**Preliminary Comments on Panama Cobre
Panama**

Expert Report prepared by:

Science Team, Environmental Law Alliance Worldwide

Centro de Incidencia Ambiental (CIAM) Panama

Figure 1: Ortofoto del 19 de octubre del 2023 que ilustra longitudes de playa de menos de 400 m durante las operaciones (Source: New Field report May 17, 2024)

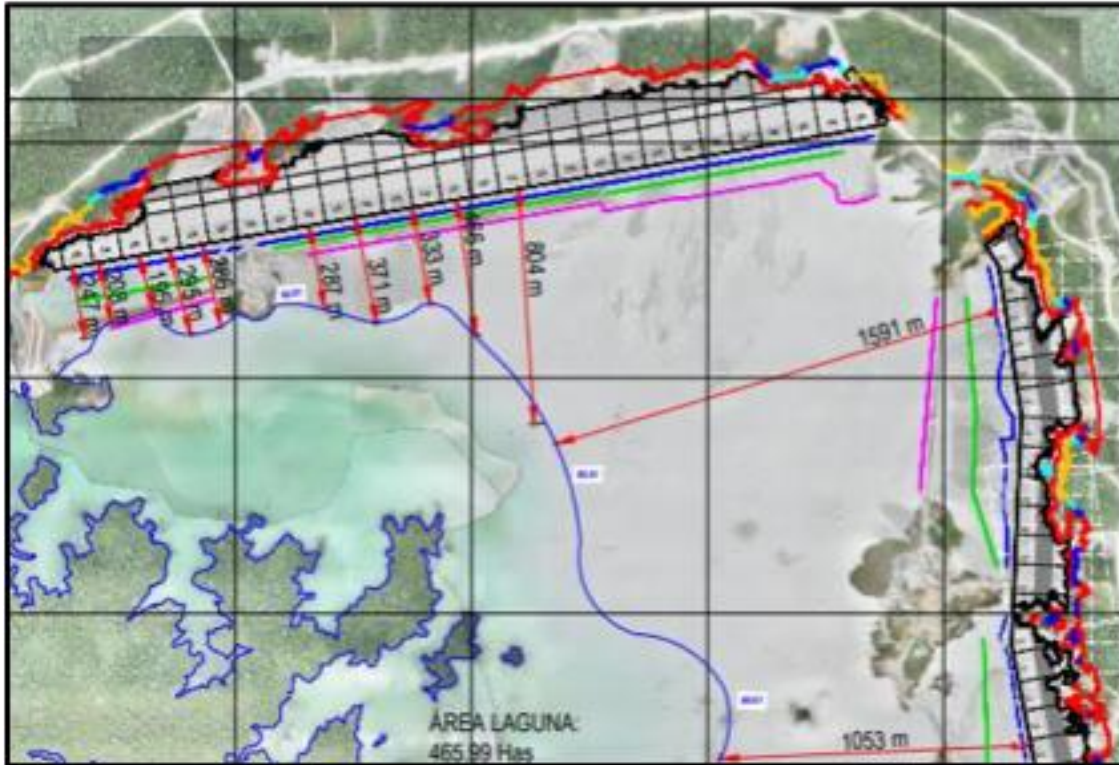
According to New Fields, the risk of failure of the North Wall of the tailings dam is because liquids in the TMF are approaching too close to the North Wall, creating the risk of erosion by seepage of liquids through the North Wall – this phenomena is referred to as “piping”. To prevent failure of the North Wall by internal erosion by this seepage pathway, liquids in the TMF should approach no closer than 400 meters to the North Wall (

Figure 1). However, in practice, liquids in the TMF are approaching as close as 195 meters to the North Bank, causing a serious risk of failure by internal erosion.

According to New Fields, the root cause of liquids in the TMF approaching too close to the North Wall is the location of the spillway, which is too close to the North Wall. According to New Fields, the solution to the problem would be to move the spillway several hundred meters to the south, which would draw liquids away from the North Wall.

Figure 2: Photo of beach width taken November 25, 2024, compared to ortophoto of beach width January 20, 2024

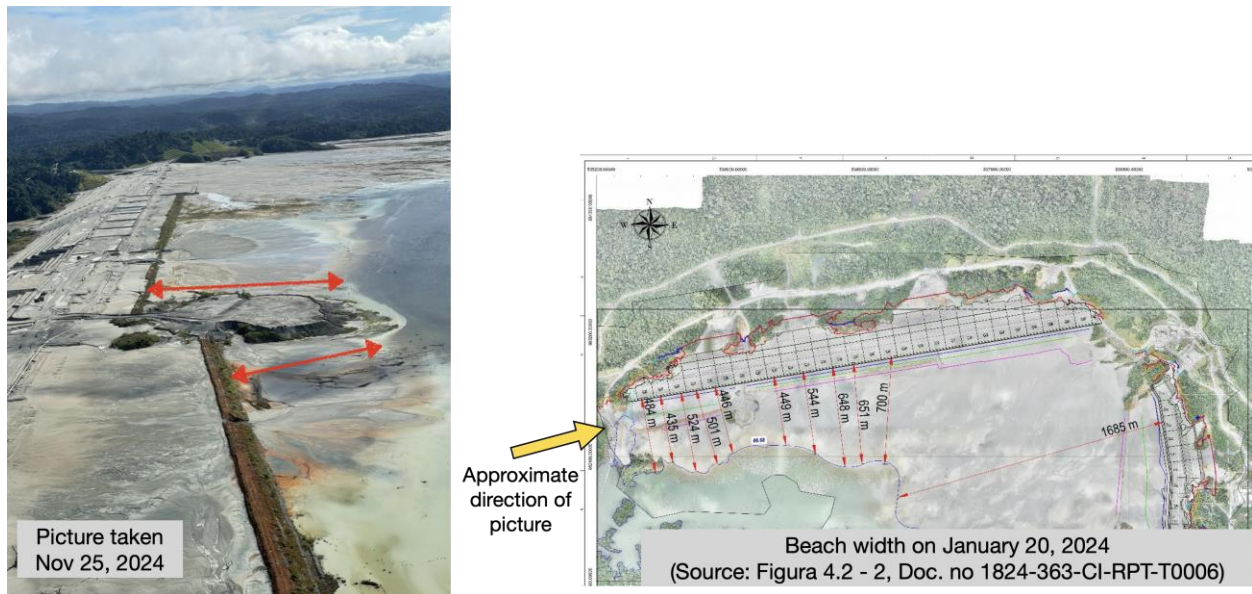
During the November 25, 2024, flight over the mine, a picture was taken showing the narrow beach (in the order of 200 m, Figure 2). This confirms the high risk of failure of the North wall (north dam).

In ELAW’s view, this risk of failure of the dam, combined with its lack of monitoring caused by non-operational inclinometers is a **VERY SERIOUS and IMMEDIATE CONCERN**. This is another reason why there should not be any further delay in closing the Cobre Panamá mine. For example, one way of reducing the possibility of failure of the North Wall, aside from relocating the spillway, would be to move material (liquids and tailings) out of the TMF, perhaps to the Botija open pit. However, these are measures that are only compatible with closure of Cobre Panamá mine and are not compatible with resumption of mining activities.

Figure 3: Zones likely impacted by mining and need for improved monitoring (Modified from Map 36, Golder, June 2010)

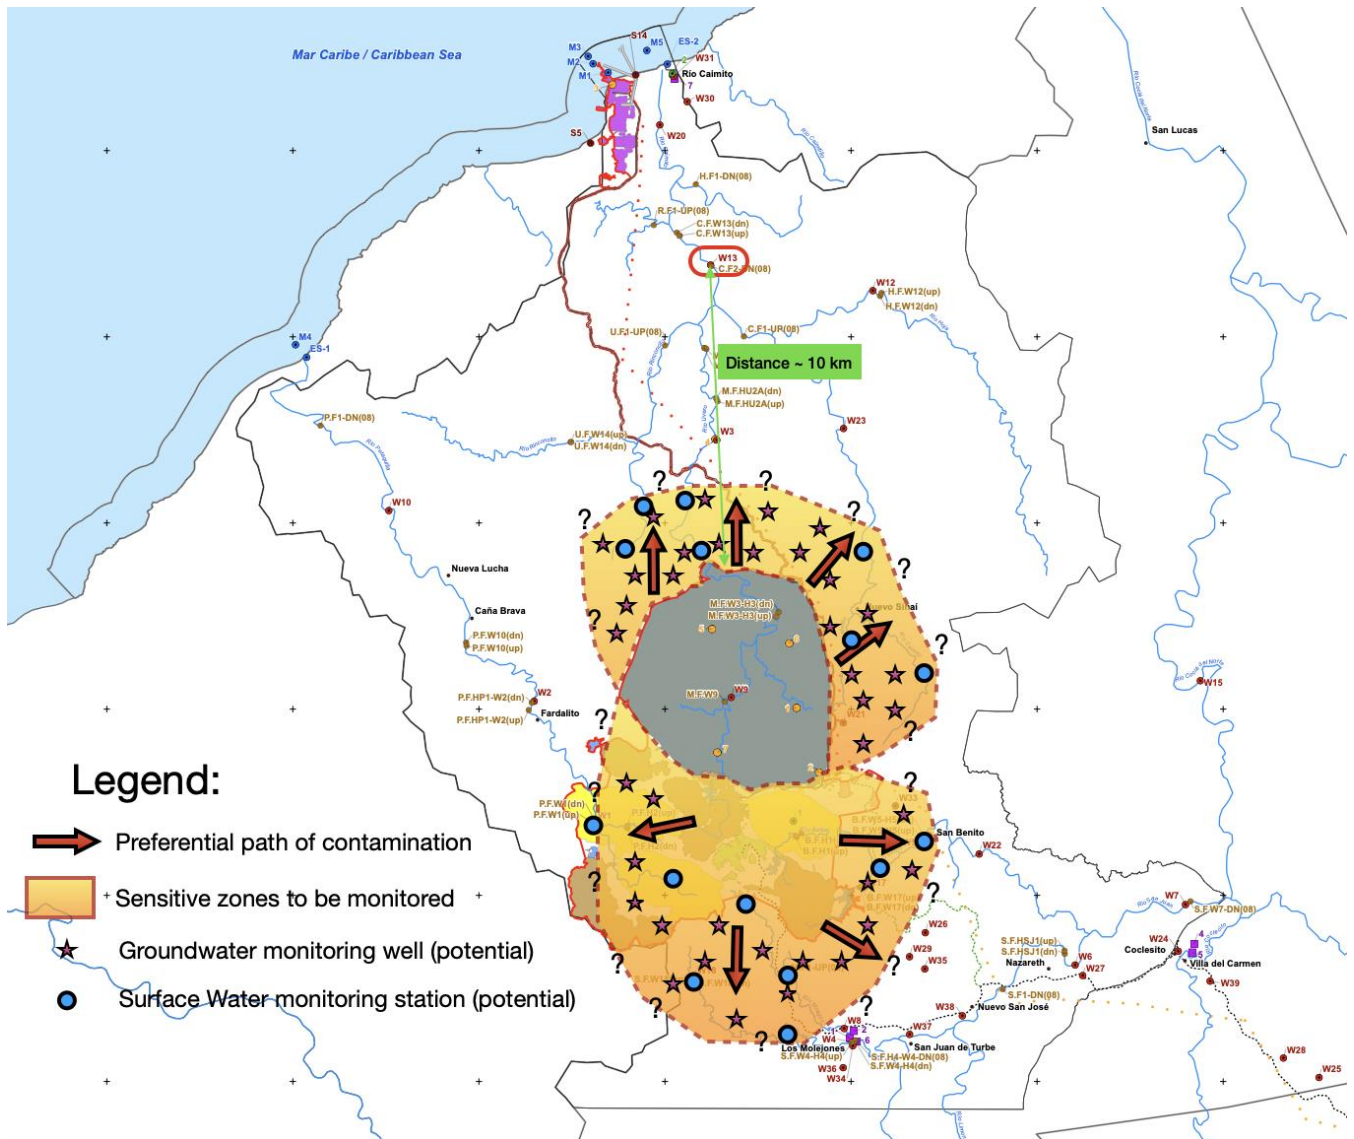
- Water quality of water (runoff within the TMF and surface water from the receiving environment) is monitored. Unfortunately, the locations where monitoring is conducted does not allow to properly assess neither the volume of groundwater impacted nor the loading by toxic elements such as copper, sulfate and selenium, etc. Copper, sulfate and selenium, among other contaminants, would be very detrimental to fish, benthic

invertebrates, and aquatic habitat. Figure 3 shows areas likely impacted by contaminants where water quality should be much better monitored (locations presented for illustration only – to be defined following additional review).

In any case, the sulfate measurements were relatively modest compared to today’s levels at sites W-13 (See location - red circle, on Figure 3) and W-15 for example during the baseline
